From: Jon Bingham <jon_br549@yahoo.com>
Sent: Friday, March 19, 2021 2:28 PM
To: St. Germain, Dante <Dante.St.Germain@louisvilleky.gov>
Cc: Sheri Lamothe <shlamothe@gmail.com>
Subject: 21-ZONE-0013 Plan comments

22-ZONE-0076

LD&T Meeting

22-ZONE-0012 & 22-ZONE-0076

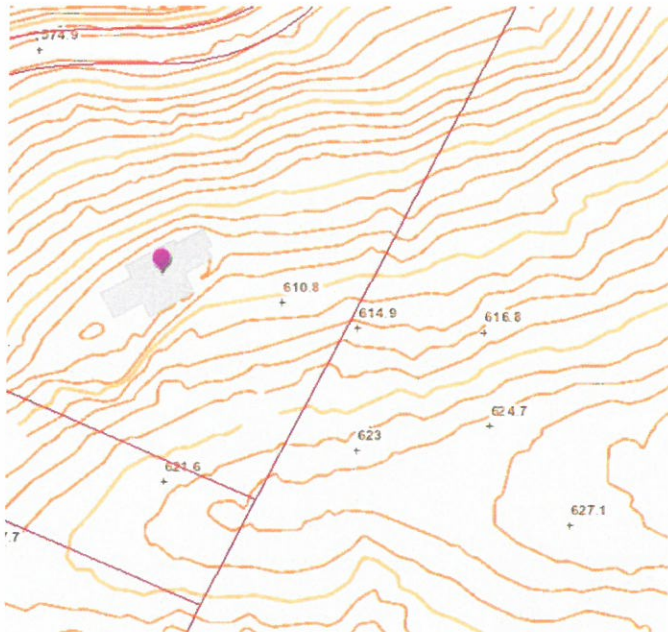
- According to section renderings, these massive 55-foot buildings are on land that is already 10 to 15-feet higher than adjacent properties. There may also be an additional 8-feet of backfill required (per geotechnical study and neighborhood meeting). Thus, these buildings will appear 78 feet to us who live below. See figure 3.1.

- For an *additional* 100-feet to be added to the setback along the North (Laurel Springs) and West (Walnut Hills Dr) sides of the property.
- Include a 6-foot berm with a 6-foot privacy fence and trees around the entire perimeter of the development at 4700 S Hurstbourne Pkwy and 4900 S Hurstbourne Pkwy.
- Leave the natural buffer along Laurel Spring Dr alone. See figure 3.4.

Figure 3.2 - Potential areas of concern for Carbon Monoxide, Plan 2040 Core Graphics (<https://louisvilleky.gov/planning-design/document/updatedcoregraphics2018pdf#page=18>)

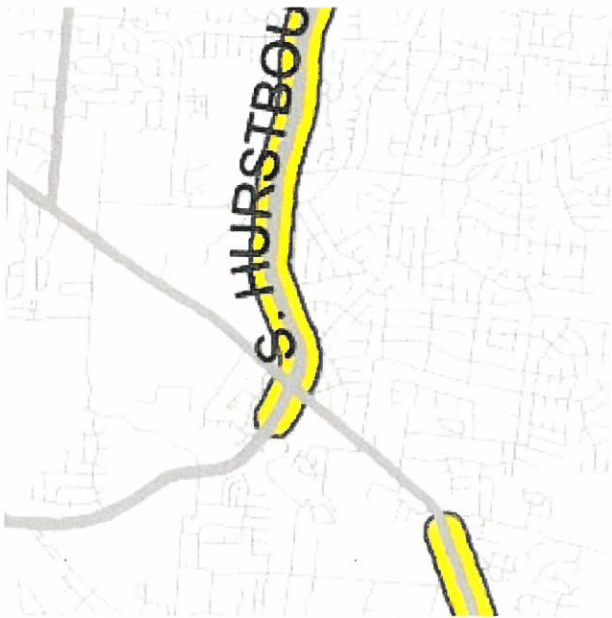
- A larger buffer zone with more trees will also help start the restoration of the mature trees that will be destroyed by the developer.
- According to Plan 2040, this area is at high risk for carbon monoxide. By adding more tree coverage along the perimeter, we can help improve the air quality and reduce health problems from carbon monoxide exposure. See figure 3.2.

Figure 5.2 - Lojic Online's identification of steep slopes around proposed development.

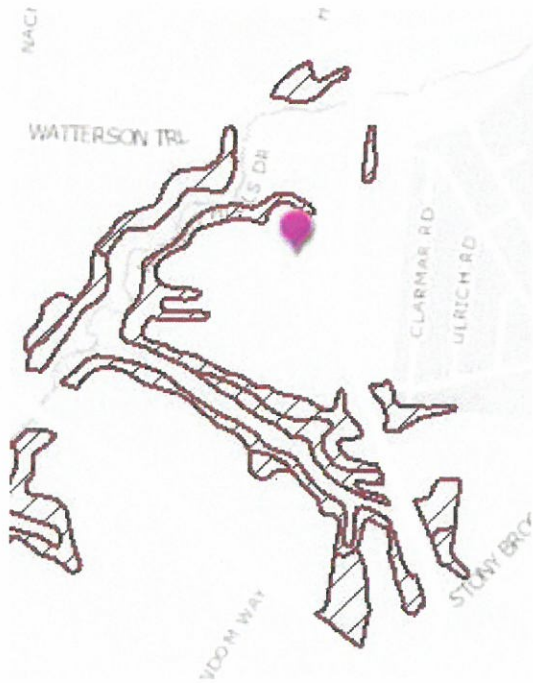
- According to Lojic Online, 4700 S Hurstbourne Pkwy is nearly surrounded by steep slopes, unlike any other development on Hurstbourne. See figure 5.2
- Due to our waterway being a FEMA Regulatory Floodway, surrounding properties are to be further regulated (according to FEMA). While the developer's property does not directly abutt to the creek, every single-family home surrounding it does. See figure 5.3

- For an unaffiliated third-party to conduct a geotechnical / impact study on the adjacent Walnut Hills and Laurel Springs properties.
